**45-DAY EXPRESS TERMS
FOR
PROPOSED BUILDING STANDARDS
OF THE
DIVISION OF THE STATE ARCHITECT (DSA-AC)
REGARDING THE CALIFORNIA BUILDING CODE
CALIFORNIA CODE OF REGULATIONS, TITLE 24, PART 2
2013 CALIFORNIA BUILDING CODE
INTERVENING CODE CYCLE**

**CHAPTER 1
ADMINISTRATION**

Figure 11B-307.4.1
Guy Braces

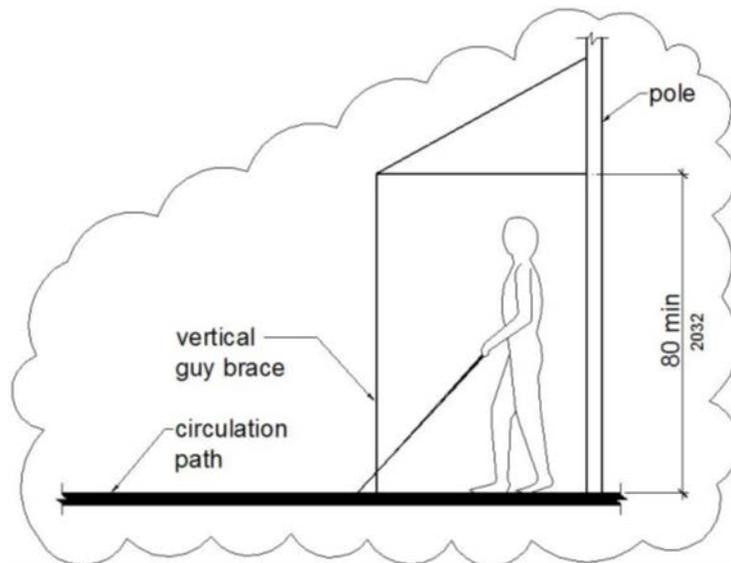
(begin underline) **11B-307.4.1 Guy braces.** *Where a guy support is used within either the width of a circulation path or 24 inches maximum outside of a circulation path, a vertical guy brace, sidewalk guy or similar device shall be used to prevent a hazard or an overhead obstruction.* (end underline)

**Figure 11B-406.2.2
Sides of Curb Ramps**

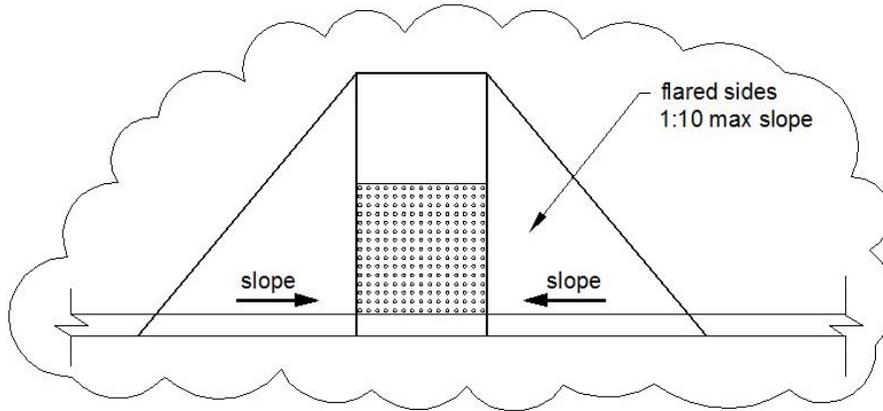
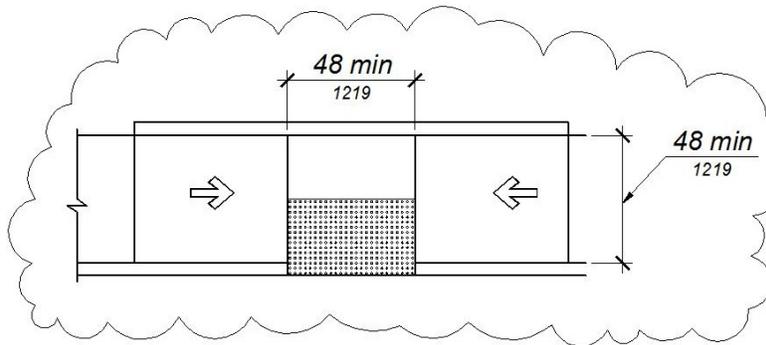
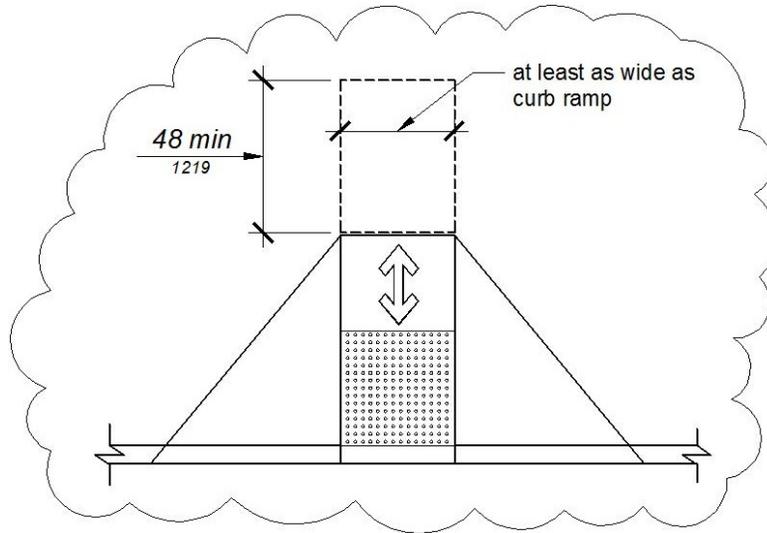
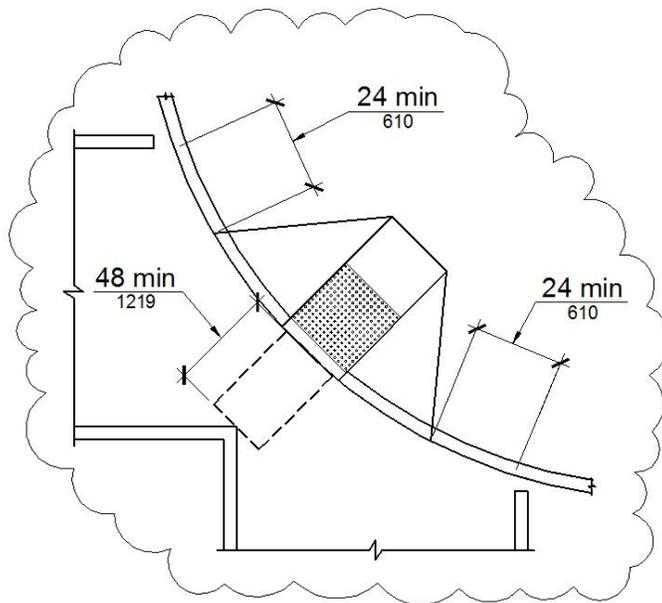
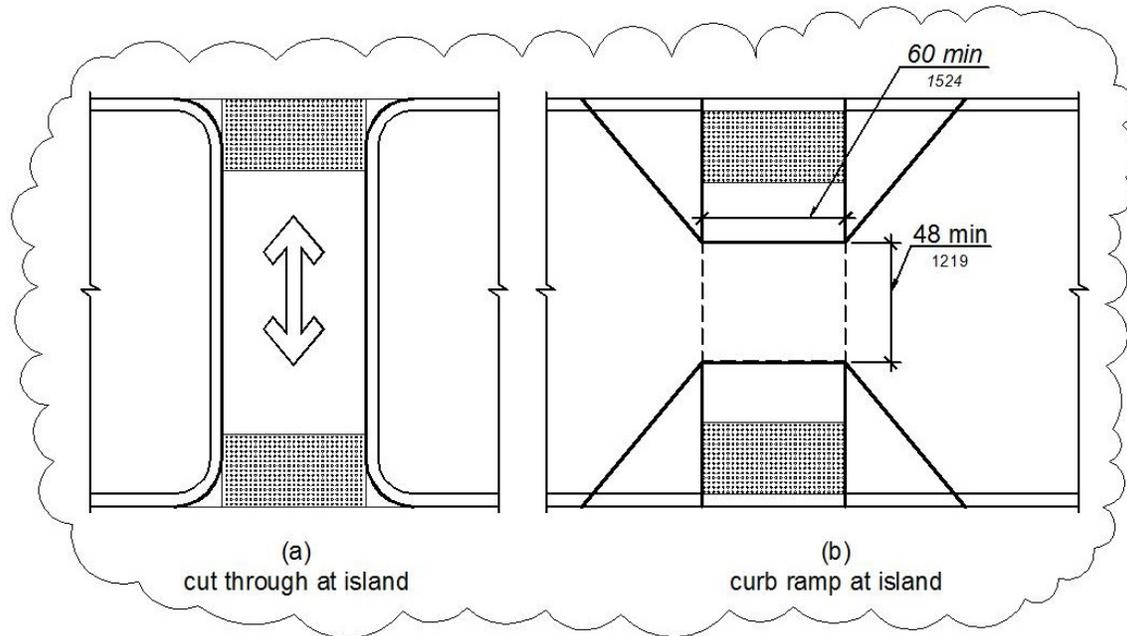
Figure (begin strikeout) ~~11B-406.5.7~~ (end strikeout) (begin underline) 11B-406.5.8 (end underline)
Counter Slope of Surfaces Adjacent to Curb Ramps

Figure 11B-411.2.1.2.3
Destination-Oriented Elevator Accessibility Function Button Indication

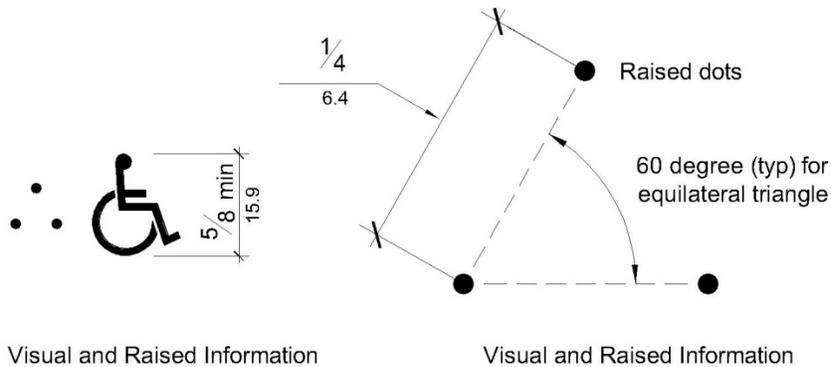
11B-411.2.1.2.3 Accessibility function button. The accessibility function button shall be identified by the International Symbol of Accessibility and a raised indication. The International Symbol of Accessibility shall comply with Section 11B-703.7.2.1, and shall be 5/8 inch (15.9 mm) minimum in height. The indication shall be three raised dots. Each dot shall have a base diameter of 0.59 inch (1.5 mm) minimum and 0.063 inch (1.6 mm) maximum and a height of 0.025 inch (0.6 mm) minimum and 0.037 inch (0.9 mm) maximum. The dots shall be spaced ¼ inch (6.4 mm), measured center to center, in the form of an equilateral triangle with a vertex pointing up. The accessibility function button shall not be provided with a key repeat function.

Figure 11B-411.2.3
Floor Designation and Car Designation Signs on Jamba
of Destination-Oriented Elevator Hoistway Signs

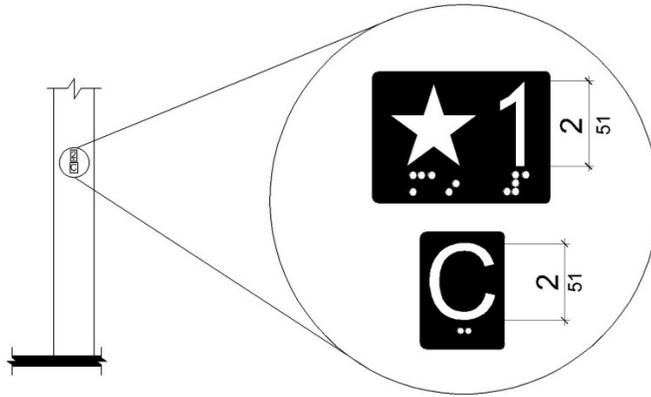
11B-411.2.3.1 Floor designation signs. Floor designation signs complying with Sections 11B-703.2 and 11B-703.4.1 shall be provided on both jambs of elevator hoistway entrances. Signs shall be provided in both raised characters and Braille. Raised characters shall be 2 inches (51 mm) high. A raised star placed to the left of the floor designation, shall be provided on both jambs at the main entry level. The outside diameter of the star shall be 2 inches (51 mm) and all points shall be of equal length. Raised characters, including the star, shall be white on a black background. Braille complying with Section 11B-703.3 shall be placed below the corresponding raised characters and the star. The Braille translation for the star shall be "MAIN". Applied plates are acceptable if they are permanently fixed to the jamb.

11B-411.2.3.2 Car designation signs. Car designation signs complying with Sections 11B-703.2 and 11B-703.4.1 shall be provided on both jambs of the hoistway immediately below the floor designation. Signs shall be provided in both raised characters and Braille. Raised characters shall be 2 inches (51 mm) high. Raised characters shall be white on a black background. Braille complying with Section 11B-703.3 shall be placed below the corresponding raised characters. Applied plates are acceptable if they are permanently fixed to the jamb.

Figure 11B-407.2.3.2
Car Designations on Jambes of Destination-Oriented Elevator Hoistway Entrances (end strikeout)

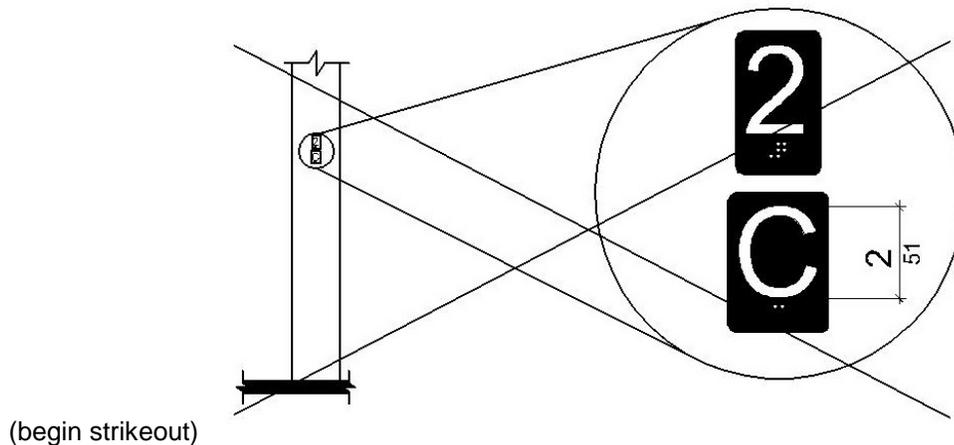
11B-407.2.3.2 (begin underline) **Reserved.** (end underline) **Car designations.** Destination-oriented elevators shall provide tactile car identification complying with Sections 11B-703.2 and 11B-703.4.1 on both jambs of the hoistway immediately below the floor designation. Car designations shall be provided in both *raised* characters and Braille. *Raised* characters shall be 2 inches (51 mm) high. *Raised* characters shall be white on a black background. *Braille complying with Section 11B-703.3 shall be placed below the corresponding raised characters.* *Applied plates are acceptable if they are permanently fixed to the jamb.* (end strikeout)

Figure 11B-703.8.5
Low Resolution VMS Signage Characters

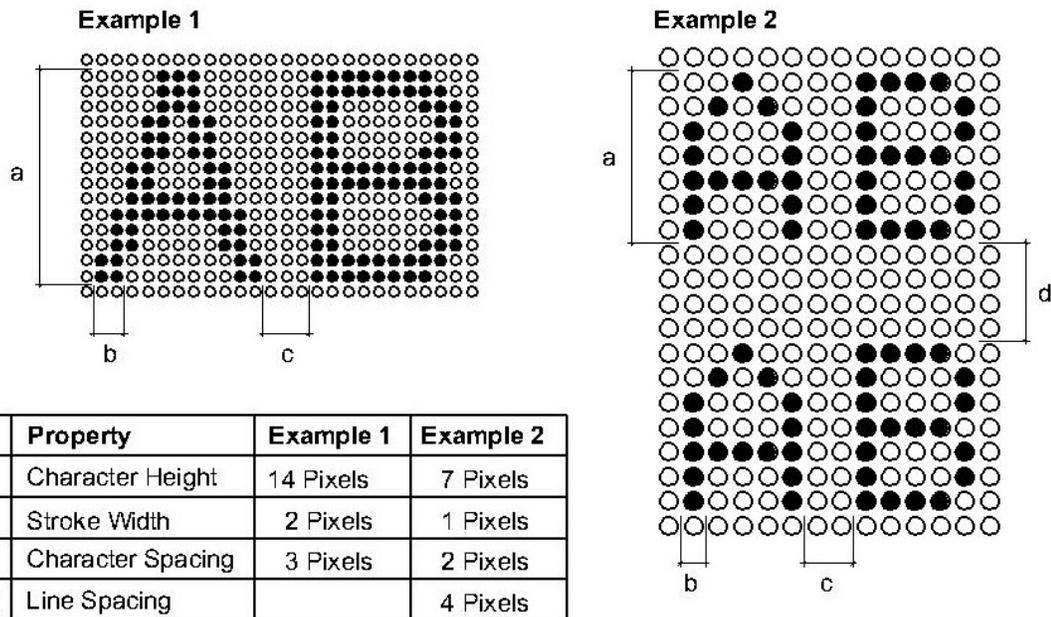
Table 11B-703.8.5 Pixel Count for Low Resolution VMS Signage

11B-703.8.6 Stroke width. *The uppercase letter “l” shall be used to determine the allowable stroke width of all low resolution VMS characters of a font. Low resolution VMS characters shall comply with the pixel count for stroke width in Table 11B-703.8.5.*

Figure 11B-604.8.1.4
Wheelchair Accessible Toilet Compartment Toe Clearance

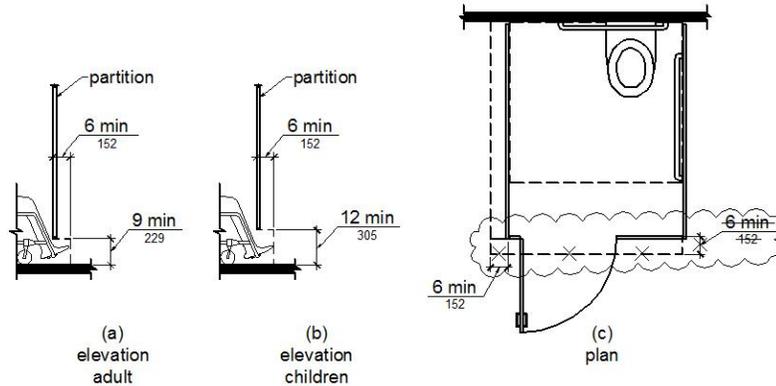
1B-604.8.1.4 Toe clearance. At least one side partition shall provide a toe clearance of 9 inches (229 mm) minimum above the finish floor and 6 inches (152 mm) deep minimum beyond the compartment-side face of the partition, exclusive of partition support members. *Partition components at toe clearances shall be smooth without sharp edges or abrasive surfaces.* Compartments for children's use shall provide a toe clearance of 12 inches (305 mm) minimum above the finish floor.

Exception: Toe clearance at the side partition is not required in a compartment greater than 66 inches (1676 mm) wide.
